John G. Haggard
Engineering Project Manager
Hudson River
July 26, 1994

RE: HUDSON RIVER REASSESSMENT RI/FS

Historical Flow Rate, Suspended Solids, and PCB Concentration
for a Spring Flood (April 1982, USGS)

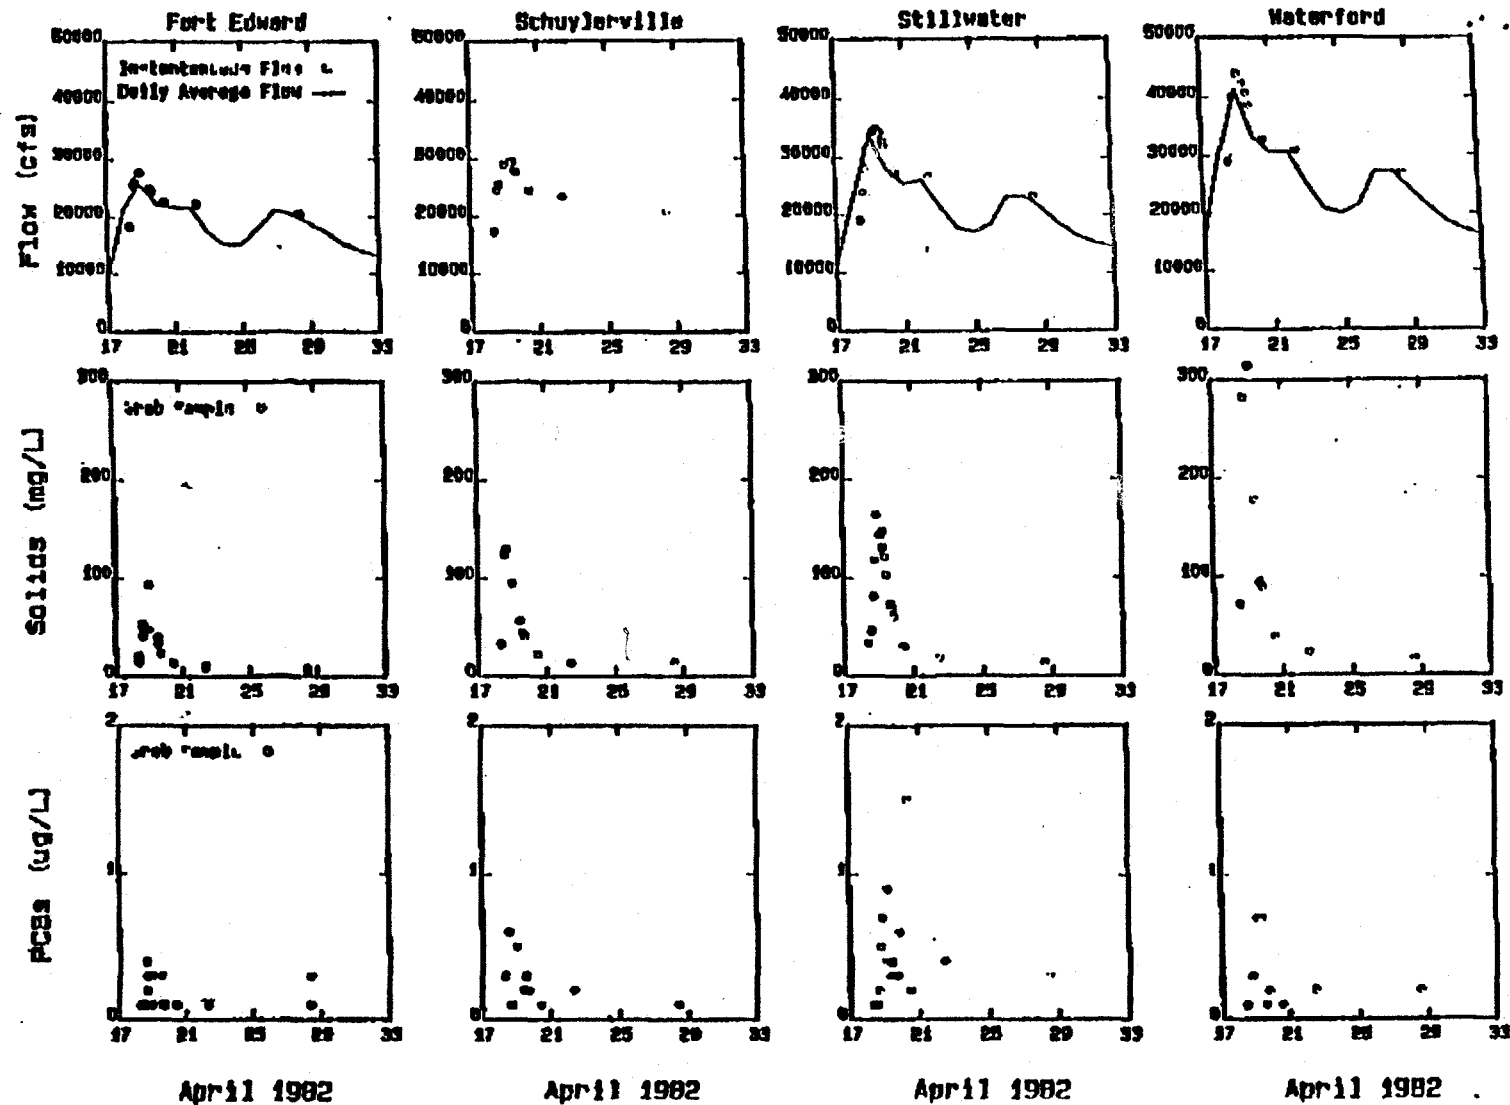
The sampling frequency identified in the sampling plan may be insufficient to characterize a resuspension event in the upper Hudson River. The sampling plan identifies a sampling frequency as five times per week for approximately five weeks during the spring high flow season. This is less than one sample per day. This sampling frequency may miss the critical flow period defined as the time at which river flows initially produce critical shear stress values which result in sediment resuspension. This typically occurs over a short period during the initial flow increase of a high flow event. Additional increases in flow beyond this initial period generally produce less sediment resuspension due to sediment armoring. That is, the deeper consolidated sediments require higher energy flows to produce a resuspension event.

The process of sediment resuspension and armoring occurs rapidly as demonstrated by TSS monitoring conducted by the US Geological Survey during the early 1980s (see attached figure). The USGS study involved the collection of samples every four to six hours. Similarly, the Thompson Island Pool TSS study conducted by General Electric in 1991 involved the collection of TSS samples every six hours. A sampling frequency of approximately every six hours would be better able to characterize a spring high flow resuspension event.
